**Phase II Report: Independent Scientific Review Panel
on Sediment Impairment and Effects on
Beneficial Uses of the Elk River and Stitz, Bear,
Jordan and Freshwater Creeks**

Authored by the Humboldt Watersheds
Independent Scientific Review Panel

Convened and Facilitated by CONCUR, Inc.
Under the Auspices of the North Coast Regional Water Quality Control Board

Report Prepared August 12, 2003

Figure 3. Schematic comparison of stream buffers for habitat versus water quality protection¹⁸

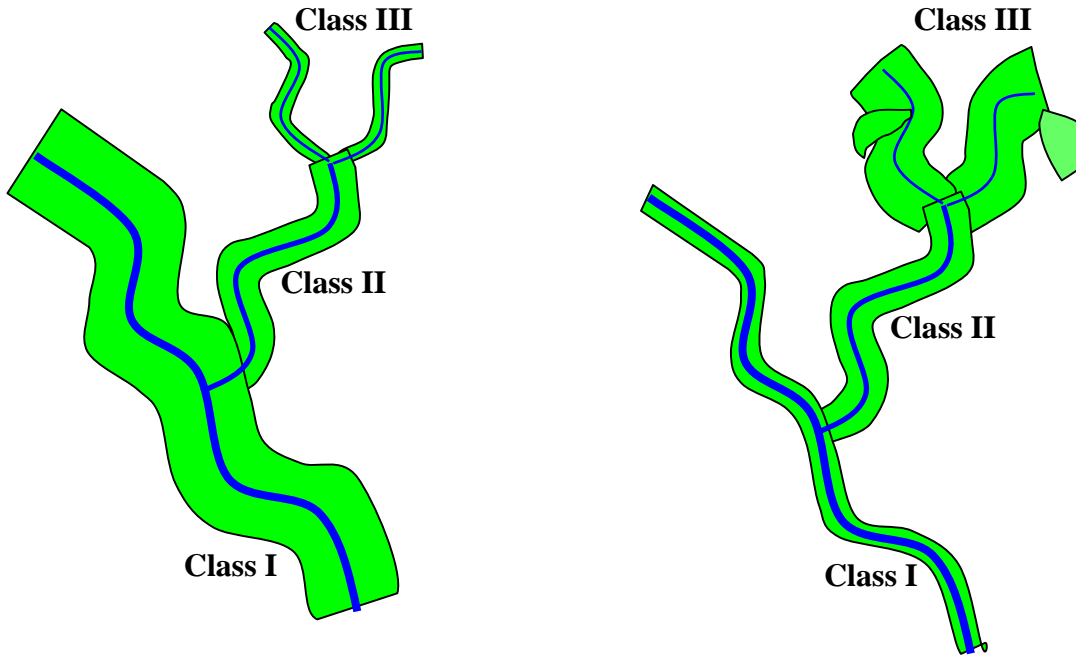
While it is logical that a plan devised to protect riparian habitat adjacent to fish-bearing streams would place more emphasis on Class I streams, a plan designed to protect water quality in non-fish bearing headwaters would place more emphasis on Class II and III streams (with the focus on protecting these streams from sediment and heating effects) than is presently the case under the HCP. PALCO is currently monitoring the effectiveness of RMZs¹⁷ and this research may shed light on the effectiveness of RMZs on water quality protection. However, the study design contains several elements that limit its usefulness as a means of assessing the effectiveness of RMZs. For example, the sampling protocol asks users to ignore erosion entering the stream from windthrown trees and from mass wasting features within RMZs. However, analysis by Reid and Hilton (1998) has shown that treefall rates (and therefore erosion rates) are higher in RMZs due to the lack of shelter from surrounding harvest areas, suggesting that such erosion should be attributed to harvesting. Likewise, mass wasting in RMZs may well be due in part to elevated pore-water pressures resulting from loss of canopy interception and evapotranspiration upslope on harvested areas.

The Panel finds that stream buffer designs that address all of the beneficial uses of water at the watershed scale could be improved by retaining the existing RMZs along Class I streams, and increasing the width of RMZs along Class II and Class III streams (see Figure 3 below). The upstream extension of robust RMZs would provide enhanced protection against accelerated sedimentation and fish habitat degradation in downstream waters of Class II and Class III streams, as well as better protection against elevated water temperatures in Class II streams. Furthermore, the Panel finds that risk of sedimentation could also be reduced if wetlands and areas with high risk of mass wasting in the watersheds were restricted from timber harvest and provided with modest no-harvest buffer zones.

Figure 6. Figure 18: Background and management-related sediment inputs over time³⁰

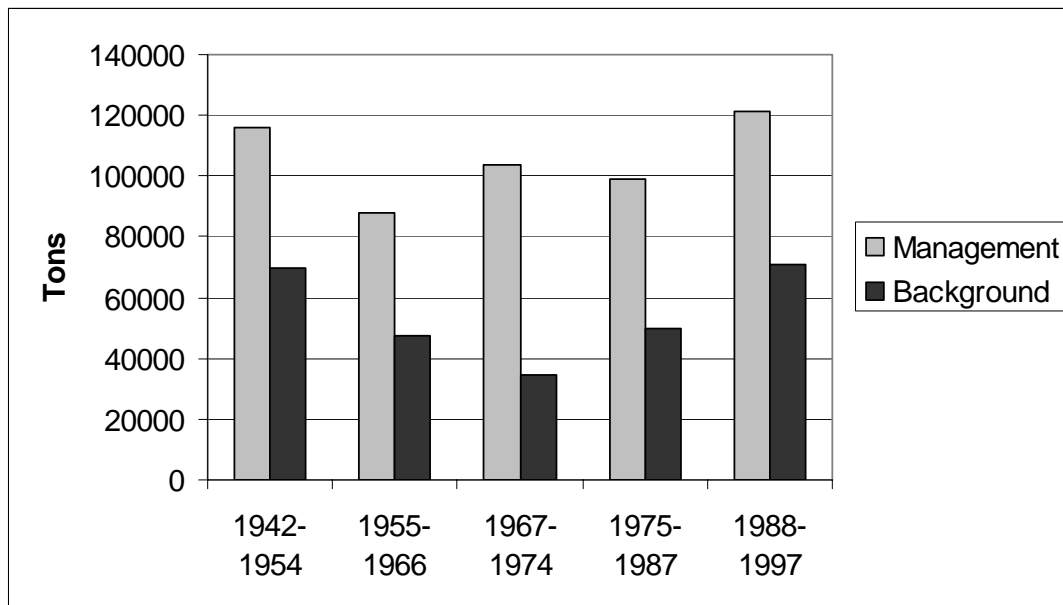
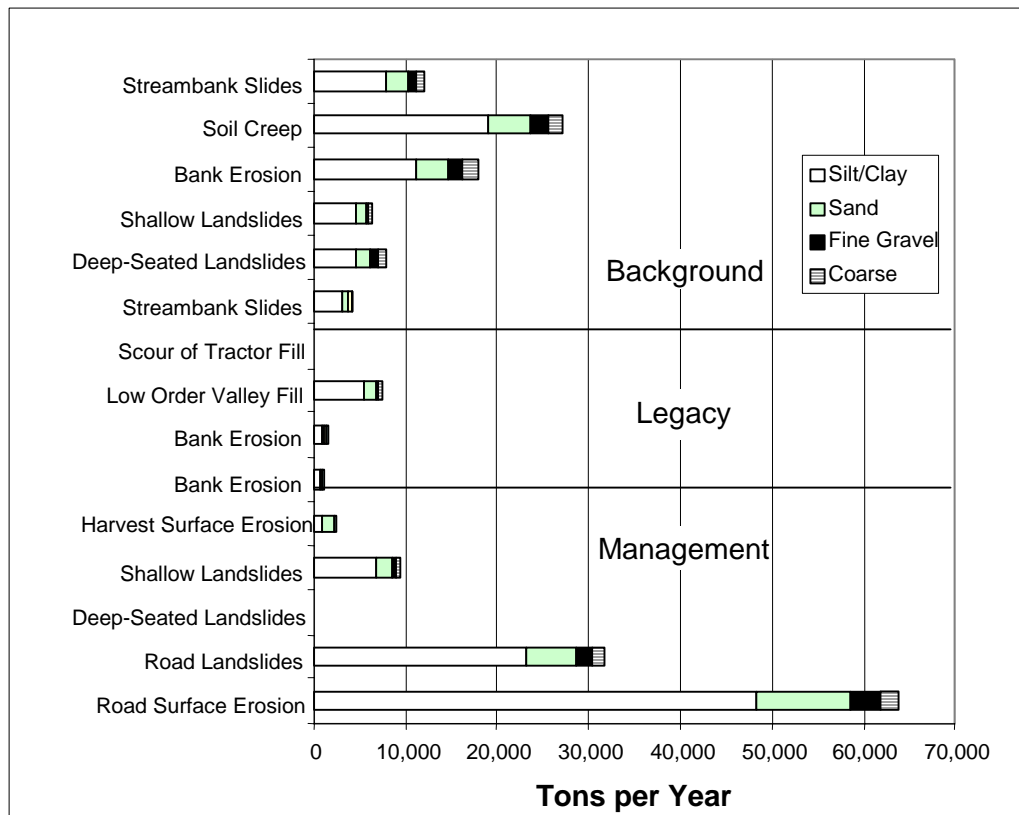
The Watershed Analysis shows that the largest source of management-related sediment load was from roads (88% of management related inputs of which 59% is from surface erosion and 29% is from road related landslides). Shallow landslides in harvest units accounted for another 9% of the management-related input, with the balance due to surface erosion from harvest units and other effects. Figures 18 and 20 from the Cumulative Effects Assessment of the Watershed Analysis illustrate the impact of management on the overall sediment budget (see Figures 6 and 7 below).

In examining these figures it is important to recognize that sediment inputs are averaged over the entire watershed, which comprises impacted (35% harvested in 10 years) and non-impacted area, so the intensity of sediment production from impacted areas is even larger than might be suggested by these figures. The Watershed Analysis identifies the processes responsible (roads and landslides) and mentions the road storm proofing program and thinning versus clear cutting on steeper slopes, but does not provide documentation of the effectiveness of these measures or the effectiveness of other lower impact measures.

Figure 8. Figure 3-3: Acres harvested during first-cycle timber harvest, 1860-1954³²

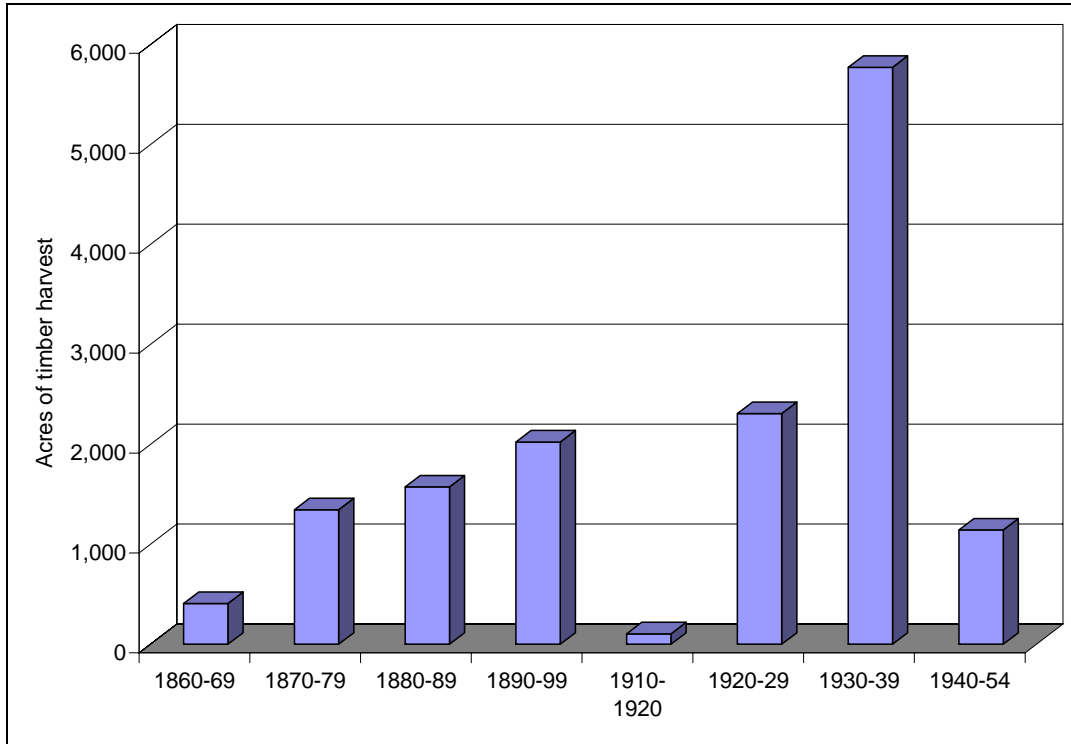
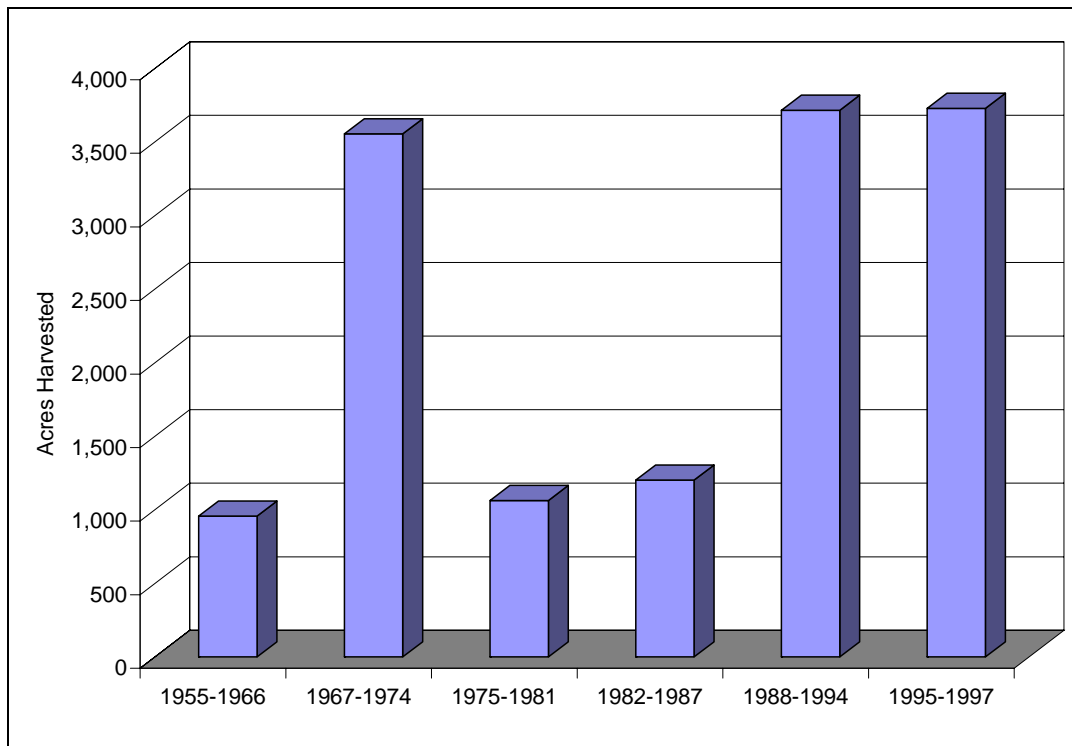
Figure 3-3 and Figure 3-4 from the Watershed Analysis Surface Erosion Assessment document the acres harvested over the history of harvest in Freshwater Creek (see Figures 8 and 9 below). The Panel calls attention to the scales. In the 10-year period (1988-1997) comprising the last two bars on Figure 3-4, the total is over 7,000 acres. This is the highest rate of harvest in the history of this watershed.

This fact is not immediately apparent in the presentation of these figures, which are reproduced here exactly as they are depicted in the Watershed Analysis. In Figure 3-3, 10-year intervals are used to show acres harvested over time, but in Figure 3-4, the 10-year period from 1988 to 1997

is reported using two bars, with 3,500 acres harvested shown in each block. Together the total number of acres harvested in 1988-1997 is 7,000, higher than any previous 10-year period. The two intervals used to report this last 10-year period are comprised of a 7-year and a 3-year interval, both of which show a harvest area of 3,500 acres, so the harvest rate for the last 3-year interval reported is more than 1,100 acres per year. This is more than double any previous harvest rate presented in these two graphs.

Figure 10. Figure 4-1: Miles of new road construction by aerial photo period³⁴

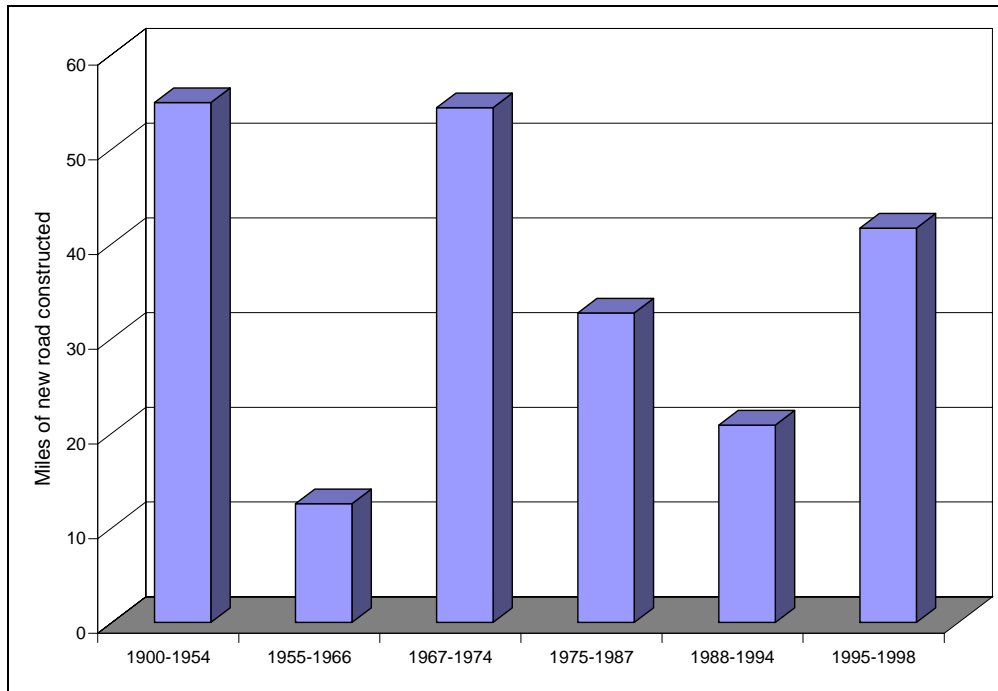
Roads are responsible for the largest component (88%) of management sediment production. Figure 4-1 from the Surface Erosion Assessment (see Figure 10 below), reports new road construction. The Panel calls attention to the years that apply to each bar. The rightmost bar indicates that 40 miles of new road were constructed in the last four years of the analysis (1995-1998) for a rate of 10 miles/year. The highest average rate in all periods prior to this was 52 miles in the 8-year period 1967-1974, for a lower rate of 6.5 miles/year. Concurrently with harvesting this watershed is also undergoing significant road construction rates. Given the way in which the data was graphed, this high rate of road construction for the latest period may not be immediately apparent.
